Access Compliance Report Public Rights-of-Way (Curb Ramps)

Main Street: HYDE_PARK_DR **Cross Street:** WICKFORD_DR **Location:** NE

ADA ID: RPRK211013111954 **Ramp Type:** Type 4 - Parallel **Initial Pass/Fail:** Fail **Overall Compliance:** No **Severity Score:** 30

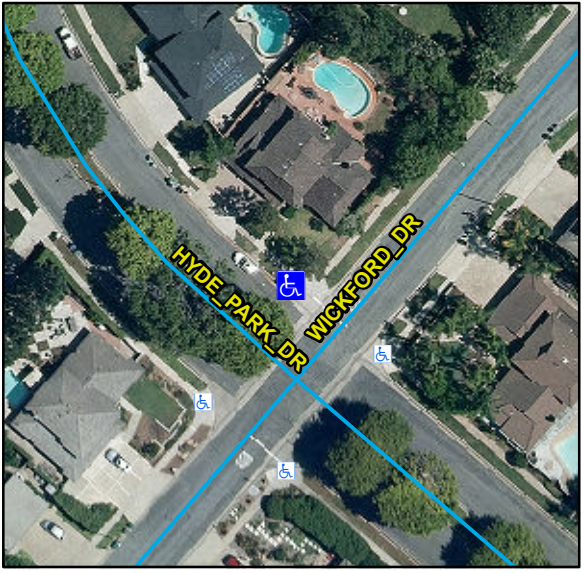
Compliance	Description	Data	Compliance	Description	Data
N/A	Ramp Length LT (in)	126	N/A	Ramp Length RT (in)	122
Yes	Ramp Width LT (in)	118	Yes	Ramp Width RT (in)	121
Yes	Ramp Run Slope LT (%)	5.7	No	Ramp Run Slope RT (%)	8.6
No	Ramp Cross Slope LT (%)	6.8	No	Ramp Cross Slope RT (%)	5.6
N/A	Landing Present	N/A	N/A	DWS Provided	N/A
N/A	Landing Length (in)	N/A	N/A	DWS Contrast	N/A
N/A	Landing Width (in)	N/A	N/A	DWS Length (in)	N/A
N/A	Landing Run Slope (%)	N/A	N/A	DWS Full Width	N/A
N/A	Landing Cross Slope (%)	N/A		DWS Offset Type	N/A
N/A	Landing Movement Obstructed?	N/A	N/A	DWS Offset Left (in)	N/A
	Landing Movement Type	N/A	N/A	DWS Offset Right (in)	N/A
N/A	Landing Shared	N/A			
N/A	Clear Space	Yes			
N/A	Clear Space To Crosswalk (in)	N/A			
N/A	Marked Crosswalk 1	No	N/A	Marked Crosswalk 2	No
	Crossing 1 Direction	SW		Crossing 2 Direction	SE
	Marked Crosswalk 1 Width (in)	N/A		Marked Crosswalk 2 Width (in)	N/A

Possible Solutions:
Remove & Replace Curb Ramp With Two New Directional Ramps or Equivalent.
